AGENDA
City of Salmon Arm
Development and Planning Services
Committee

SUBJECT: Development Permit Application No. DP-450 (Commercial City Center)
 Legal: Lot 7, Section 10, Township 20, Range 10, W6M, KDYD, Plan 3991 Except
 Plans KAP76141 and KAP76862
 Civic: 1160 10 Avenue SW
 Owner: Dhaliwal Investments Ltd. And Kandola Investments Ltd.
 Applicant: Vic Van Isle Construction 2020 Ltd.

TO: Director of Development Services
DATE: April 6, 2023
PREPARED BY: Chris Moore, Engineering Assistant
APPLICANT: Dhaliwal Investments Ltd.
SUBJECT: DEVELOPMENT VARIANCE PERMIT No. DP-450
LEGAL: Lot 7, Section 10, Township 20, Range 10, W6M KDYD PLAN 3991 EXCEPT
PLANS KAP76141 AND KAP76862
CIVIC: 1160 – 10 Avenue SW

TO: Gary Buxton, Director of Planning
 DATE: 04 April 2023
 PREPARED BY: Chris Moore, Engineering Assistant
 APPLICANT: T. & L. Lepp - 1091 – 60 Street NW Salmon Arm, BC V1E 3B2
 SUBJECT: VARIANCE PERMIT APPLICATION FILE NO. VP- 578
 LEGAL: Lot 1, Section 20, Township 20, Range 10, W6M, KDYD, Plan 33563
 CIVIC: 1091 – 60 Street NW

Sketch Plan of Proposed Subdivision of Part of Lot 1, Tp 20, Rge 10, W6M, KDYD, Plan 33563

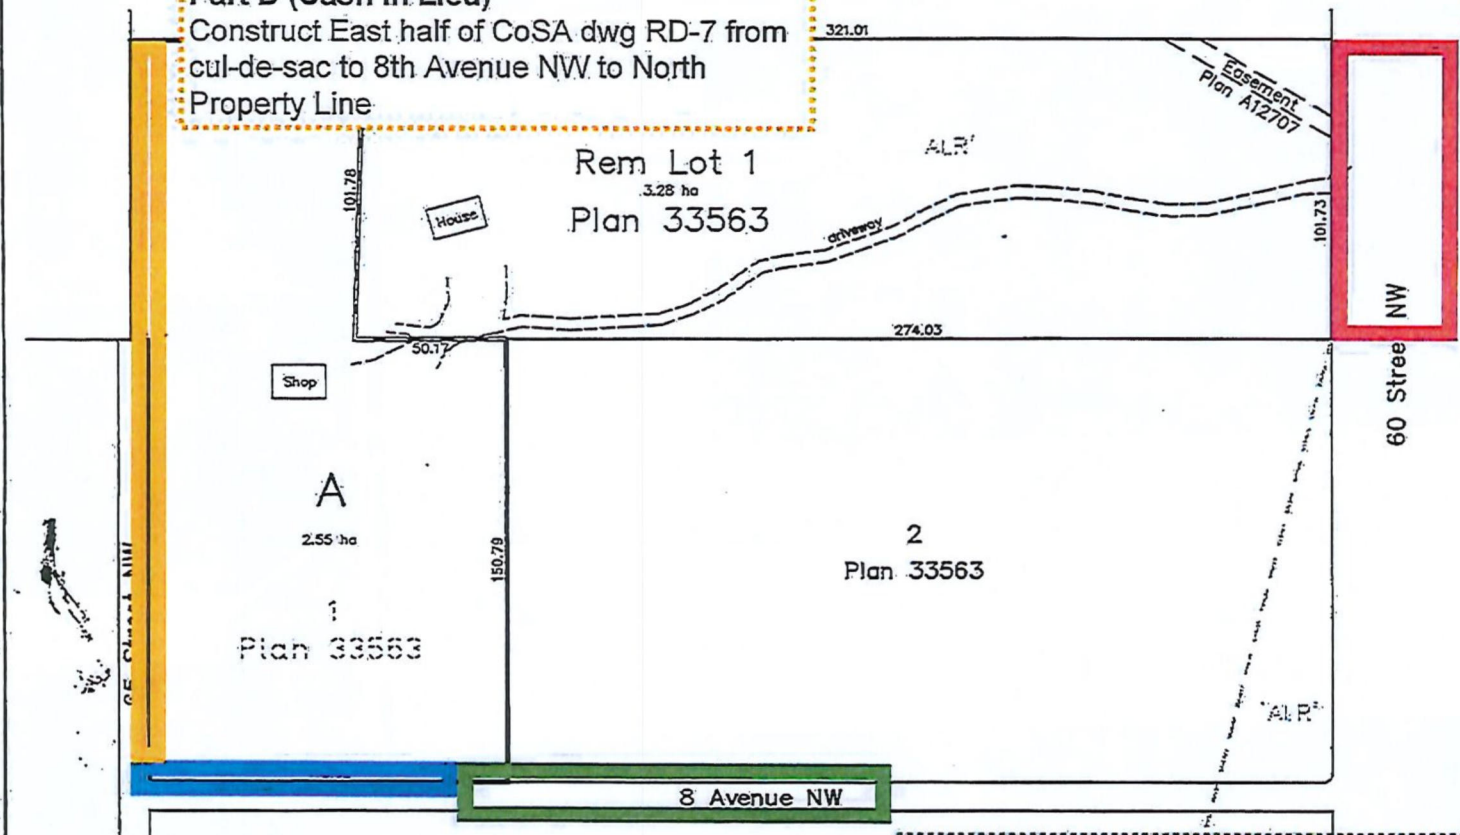
Construct East half of CoSA dwg RD-7 from cul-de-sac to 8th Avenue NW to North Property Line

Upgrade West half of 60th Street NE to CoSA dwg RD-8.

The Engineering Department recommends that the request to waive the requirement for additional dedication on 65 Street NW be denied, but (given the limited development potential off 65 Street NW) would support reducing the ROW width from 20m to 18m, which equates to a ROW dedication of 3.971m from the southern portion of 65 Street NW and 9.0m from the northern portion (to be confirmed by a BCLS). This dedication is required to allow for the future construction of 65 Street NW and development of adjoining properties.
